Central Planning Authority

Agenda for a meeting of the Central Planning Authority to be held on **27 March 2024 at 10:00am** in Conference Room 1038, 1st Floor, Government Administration Building, 133 Elgin Avenue

CPA/10/24

Figure 1: Land cover map overlaid on proposed site plan, note the majority of the site is covered by tidally flooded mangrove forest and woodland (Source: DoE, 2023)

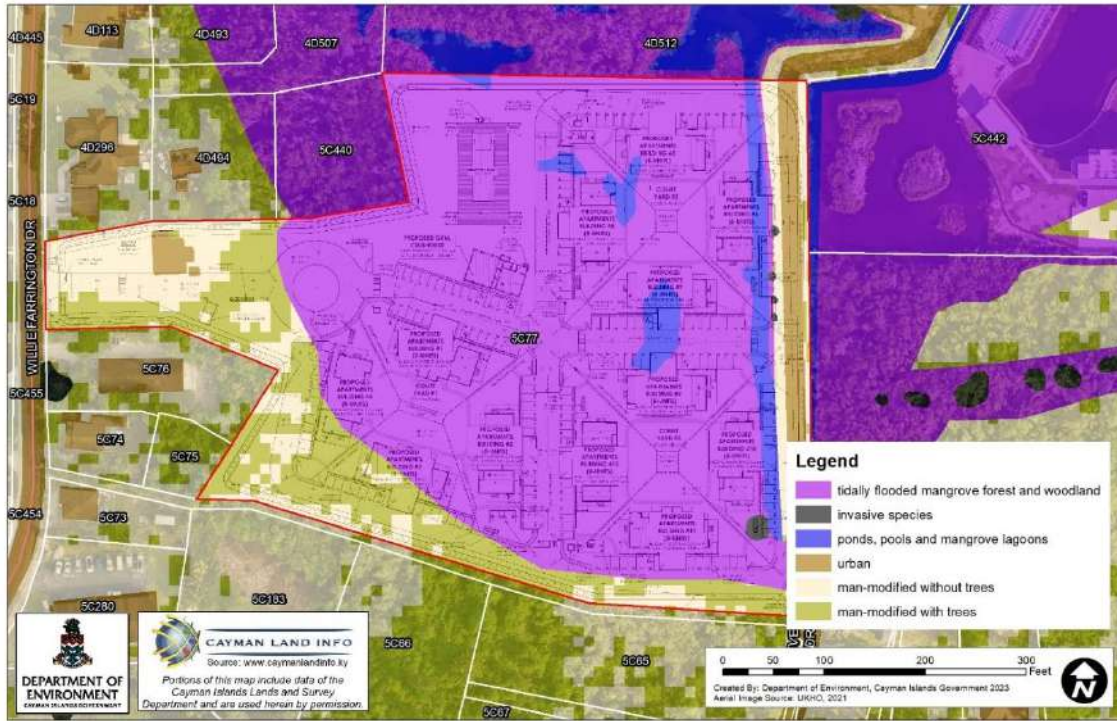
The application site consists primarily of tidally flooded mangrove forest and woodland (refer to Figure 1) and features several ponds or pools.

Figure 2: Site contours overlaid on 2018 aerial imagery (Source: LIS, 2018)

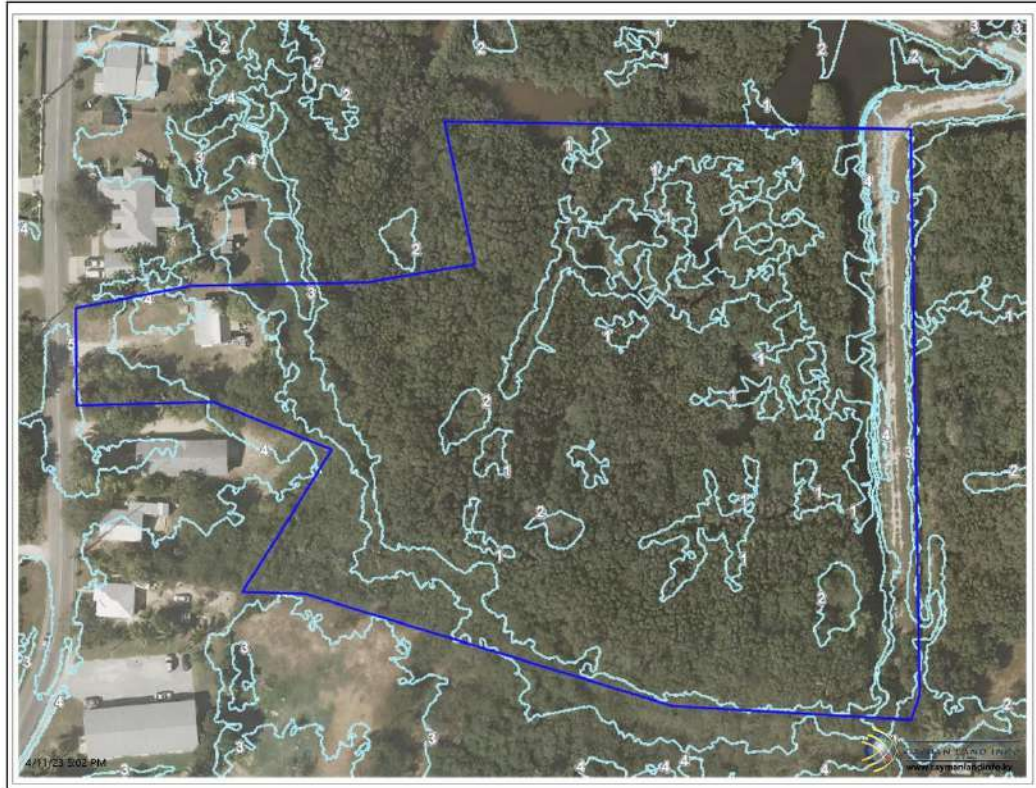
The site is very low lying, averaging around 1 foot above Mean Sea Level (refer to Figure 2). As such, drainage is likely to be a significant concern. We are pleased to see that the revisions to the plan feature a number of areas that have been used to incorporate detention basins or retention ponds and the perimeter of the property features a swale. If incorporated effectively, these measures can be beneficial to the drainage of the site, as well as the surrounding area. We have not been provided with a comprehensive Stormwater Management Plan for detailed review, however we do support the inclusion of these aspects.

We further recommend that the applicant considers the use of porous or permeable paved surfaces in areas of hard standing such as the driveways and parking areas.

Figure 2: A map showing the elevation of the subject parcel with the elevated ridge shown in yellow reaching approximately 24ft above sea level (Source: LIS 2018)

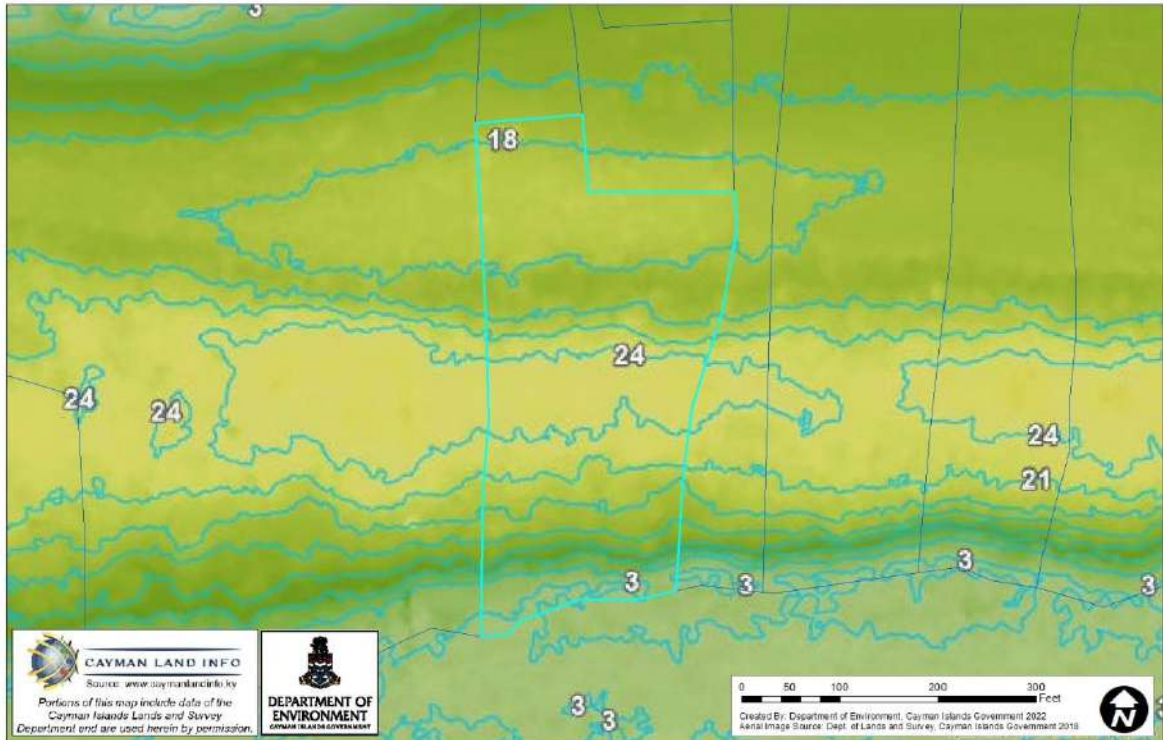
The Department notes that the majority of the subject parcel is primary dry shrubland and dry forest habitat with the northern-most section being previously cleared and man-modified, as shown in Figure 1 below. The subject parcel is also located on an elevated ridge area which reaches heights of approximately 24ft as shown in Figure 2 below. Elevated areas with primary dry forest habitats are known to contain some of the oldest growth native vegetation. These areas are of high ecological value and may contain endemic species.

Should the Central Planning Authority or Planning Department be minded to grant planning permission for the proposed subdivision, the DoE recommends the inclusion of the following conditions in any Planning Approval:

1. *There shall be no land clearing, excavation, filling or further development of the resultant subdivided parcels without planning permission for such works being granted.*
2. *Any future land clearing, excavation, filling or development of the resulting subdivided parcels shall be the subject of a separate consultation with the Central Planning Authority and National Conservation Council.*
